GENERAL ELECTRIC

SUBJECT: IN THE MATTER OF 238 NUCLEAR ISLAND
GENERAL ELECTRIC STANDARD SAFETY ANALYSIS REPORT
(GESSAR II) DOCKET NO. STN 50-447

DRAFT AMENDMENT PERTAINING TO CP/ML AND SRP RULES

DRAFT OF GESSAR II
AMENDMENT NO. 17
RESPONSE TO CP/ML RULE

Figure 1G.47-2
Top Level Management Oversight
and Technical Control

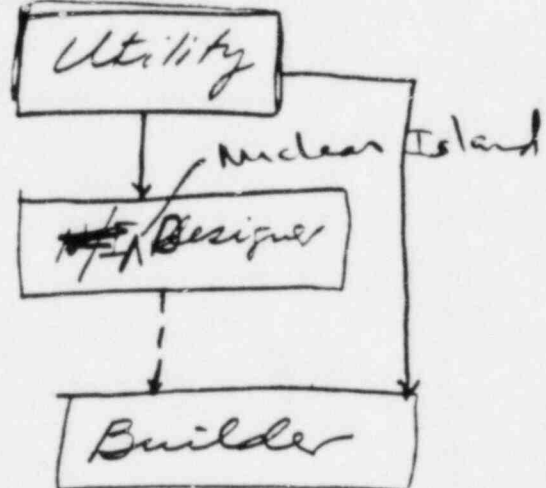
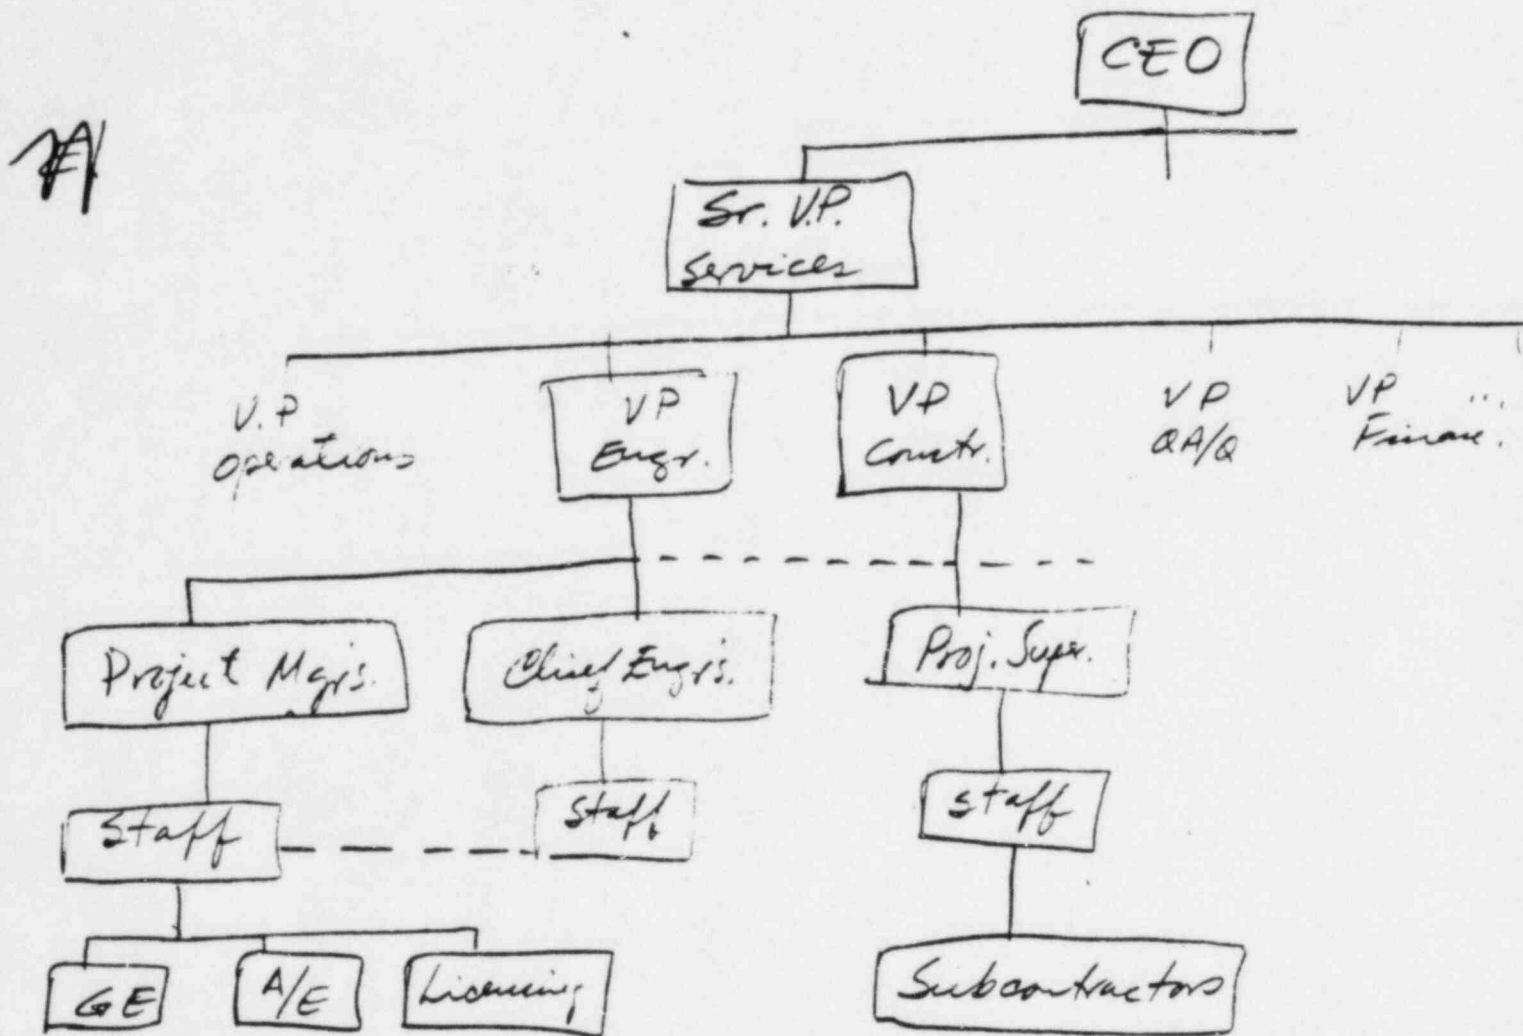
(A) The organizational and management structure is depicted in Figure 1G.47-1.

Jack: We can add more "fluff" here regarding what we did in STRIDE to control design.
